RE: Permit No. M-2016-054 - Irwin Thomas Mine, Technical Revision (TR-03)  
Adequacy Review #1 Response

IRWIN-THOMAS MINE

Exhibit C - South Mining Plan Map

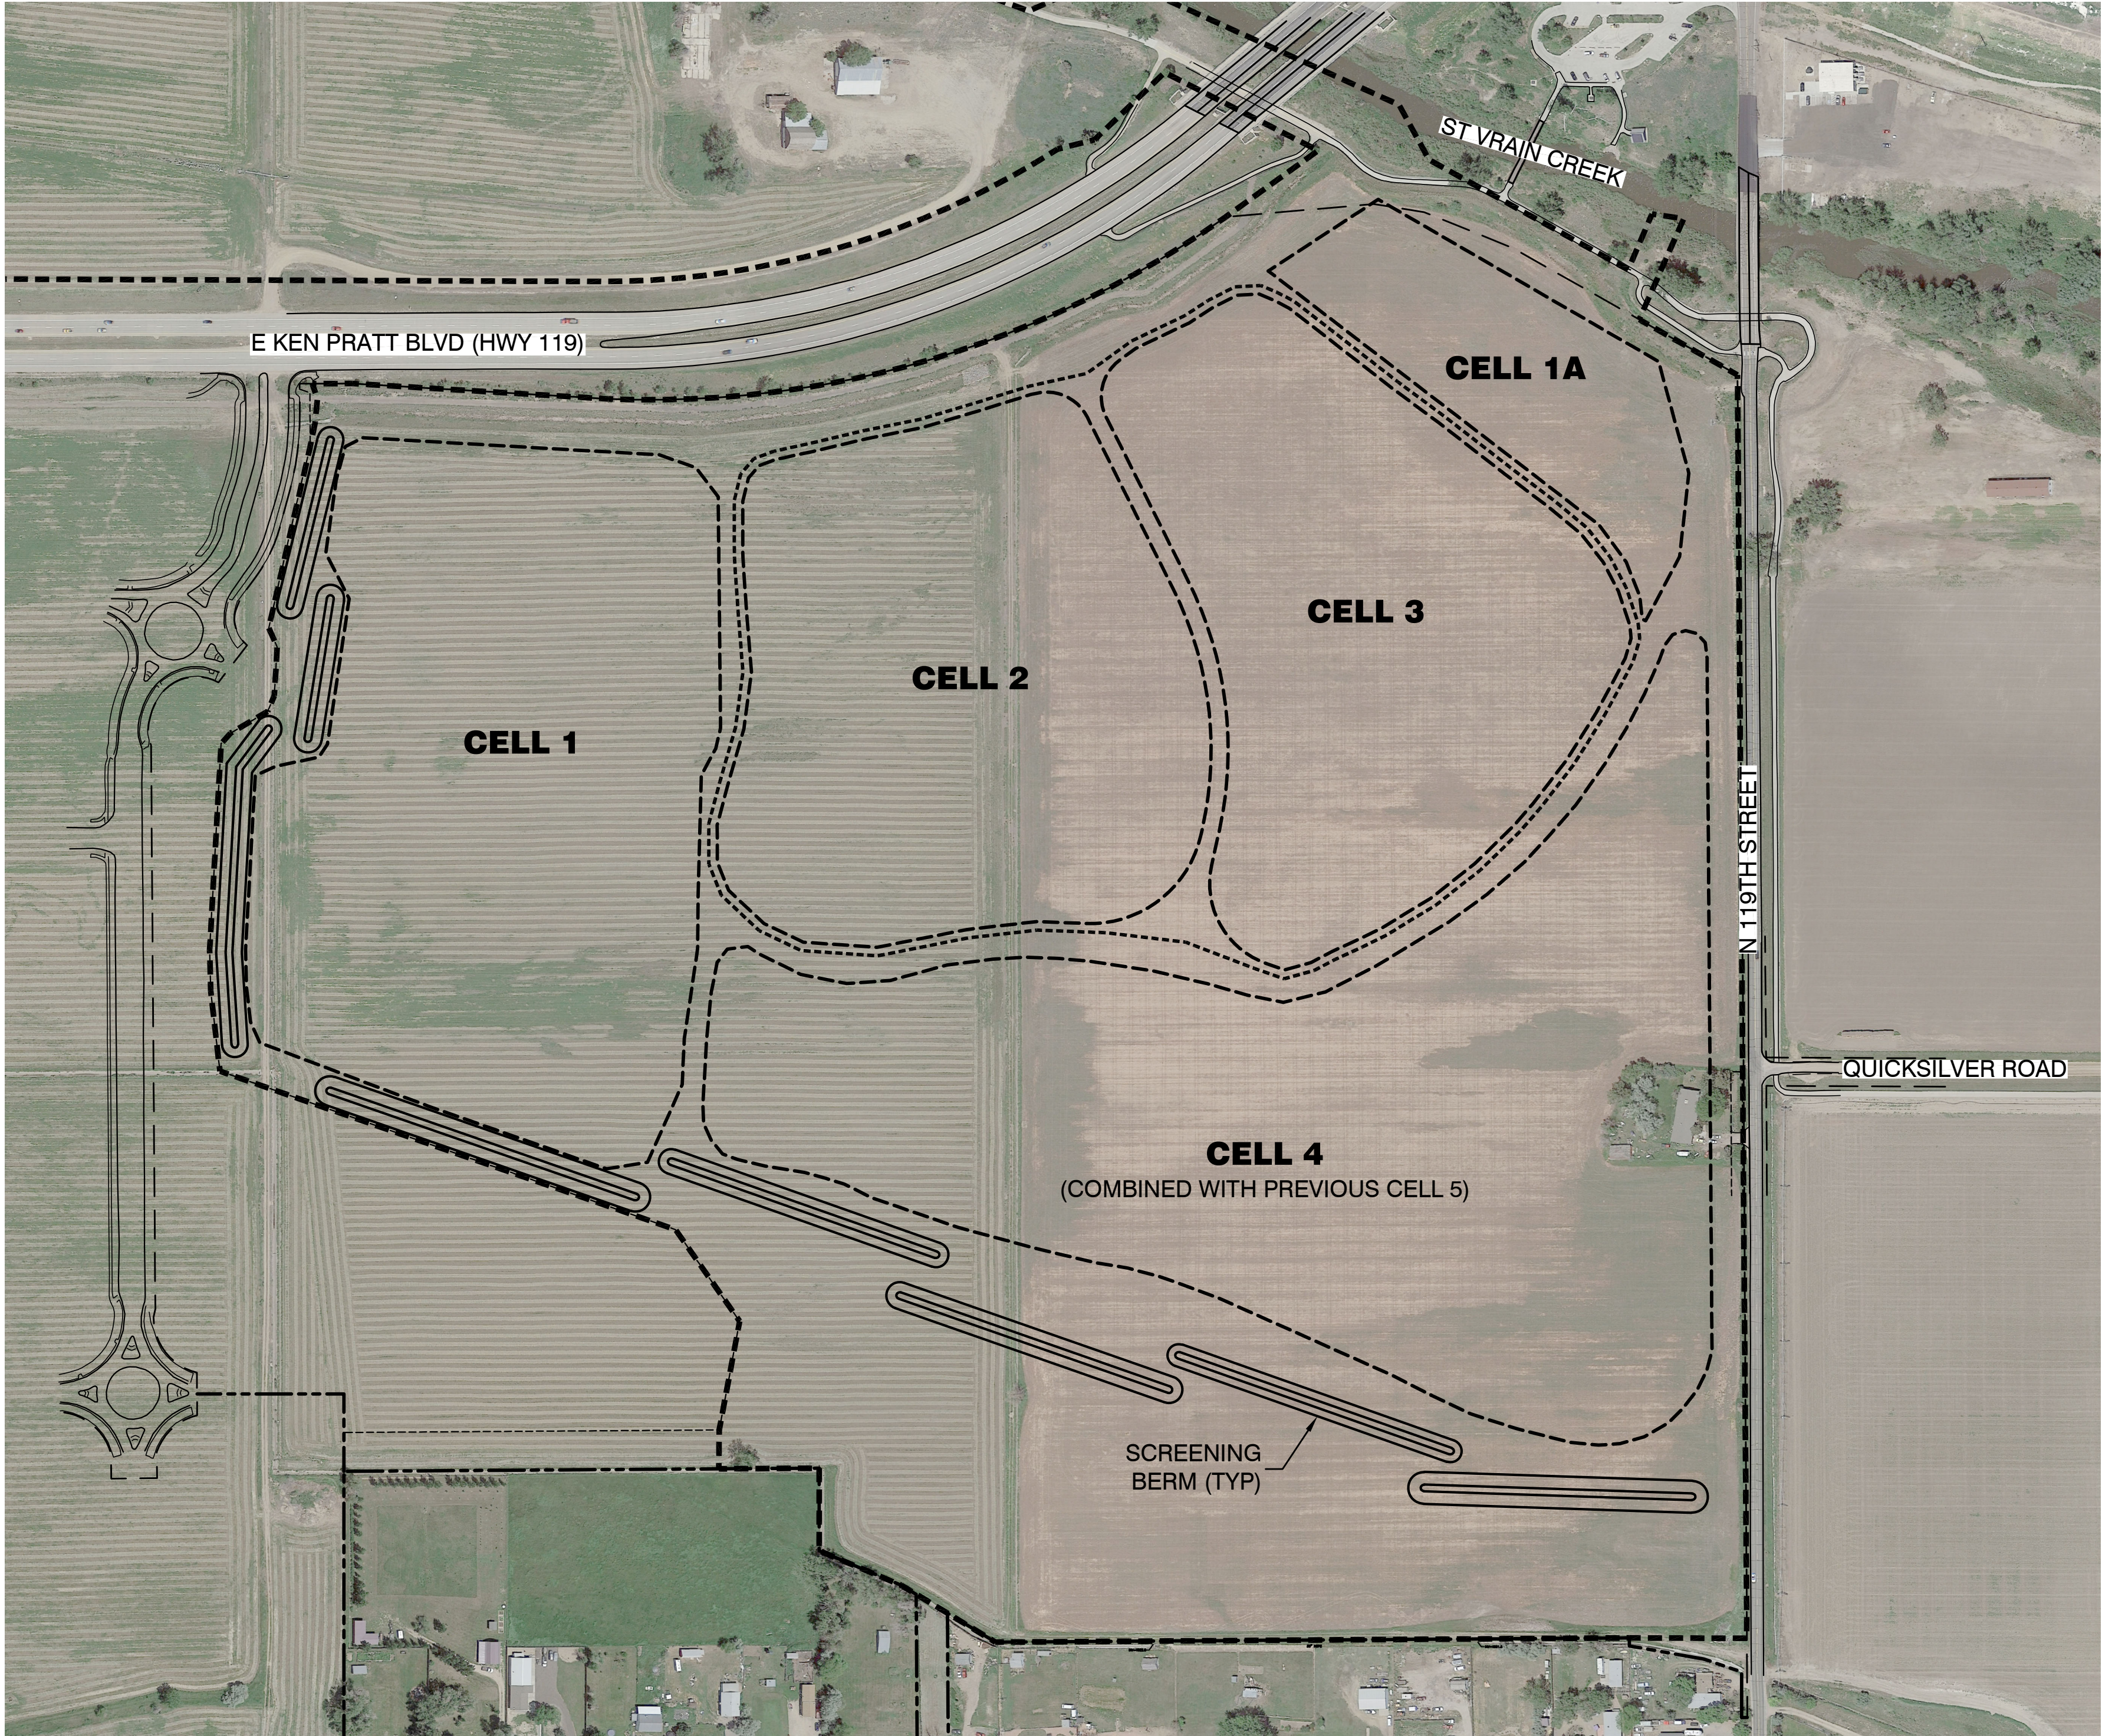
- 2.) The map provided in the submittal does not accurately show the approved permit boundary. Please use the attached boundary map exhibit, with provided coordinates, to update the map with approved permit boundary and resubmit the map.

Attached revised map.
